Access Compliance Report

(Curb Ramps)

Intersection ID: N/A	Main Street: DURANT_BV	Cross Street: KESSLER_DR	Location: N
ADA ID: DD980CCDD5C9	Ramp Type: PerpDiag	Initial Pass/Fail: Fail	Overall Compliance: No
		Severity Score: 42.5

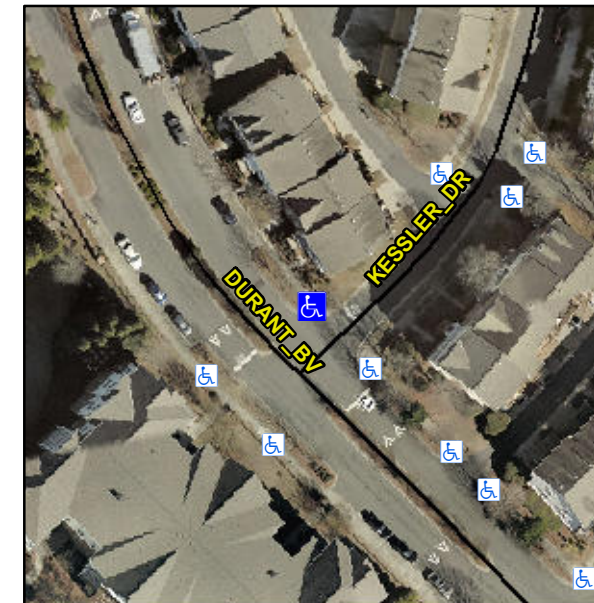
Not Found, R304.5.1, R304.5.3

Compliance	Description	Data	Compliance	Description	Data
N/A	Ramp Length (in)	119.0	Yes	Ramp Slope (%)	5.8
No	Ramp Width (in)	33.0	No	Ramp XSlope (%)	7.9
N/A	Flare Type LT	N/A	N/A	Flare Type RT	N/A
N/A	Flare Slope LT (%)	N/A	N/A	Flare Slope RT (%)	N/A
N/A	Flare Traversable LT?	N/A	N/A	Flare Traversable RT?	N/A
N/A	Landing Length (in)	N/A	N/A	DWS Provided?	N/A
N/A	Landing Width (in)	N/A	N/A	DWS Contrast?	N/A
N/A	Landing Slope (%)	N/A	N/A	DWS Length (in)	N/A
N/A	Landing X Slope (%)	N/A	N/A	DWS Full Width?	N/A
N/A	Landing Curb? (Y/N)	N/A	N/A	DWS Offset (in)	N/A
N/A	Shared Landing?	N/A			
N/A	Gutter Ponding?	N/A	N/A	Gutter Slope (%)	N/A
N/A	Gutter Lip Ht (in)	N/A	N/A	Gutter X Slope (%)	N/A
N/A	Painted X Walk1?	No	N/A	Painted X Walk2?	No
	X Walk 1 Direction	To SW		X Walk 2 Direction	To SE
N/A	X Walk 1 Width (in)	N/A	N/A	X Walk 2 Width (in)	N/A
	X Walk 1 Slope (%)	2.7		X Walk 2 Slope (%)	6.3
	X Walk 1 X Slope (%)	5.3		X Walk 2 X Slope (%)	0.5

Remove & Replace Curb Ramp With Two New Directional Ramps or Equivalent.
